# County of Santa Clara

**FILE NUMBER:** PLN22-137  
**SUBJECT:** Building Site Approval and Design Review Tier III  
**SITE LOCATION:** 15581 Glen Una Drive, Los Gatos, CA 95030-2908 (APN: 510-26-007)  
**DATE RECEIVED:** August 2, 2022

Building Site Approval and Design Review Tier III (15581 Glen Una Drive, Los Gatos )

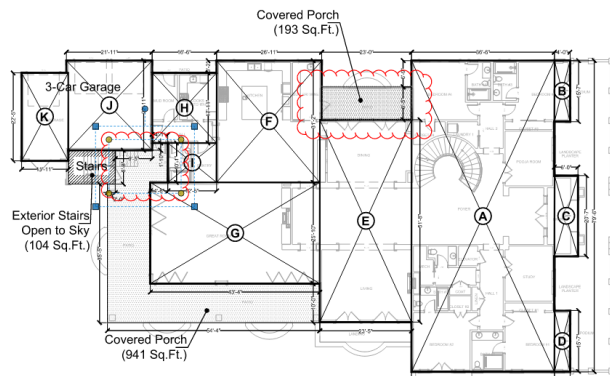
9. Please update the floor area calculation to include the area of the covered porch (193 sq.ft.) and the portion of the patio that is adjacent to Garage and restroom (shown in the bellow picture). Per County of Santa Clara Zoning Ordinance section §1.30.030, “floor area” includes “the total area of any attached garage, and any carport, porch or similar attached structure or feature that is both: (a) covered, and (b) greater than 50% enclosed by perimeter walls.”

*FLOOR AREA CALCULATION ON COVER SHEET DOES INCLUDE THE COVERED PORCHES (HIGHLIGHTED IN THE MARKUP) Fences*
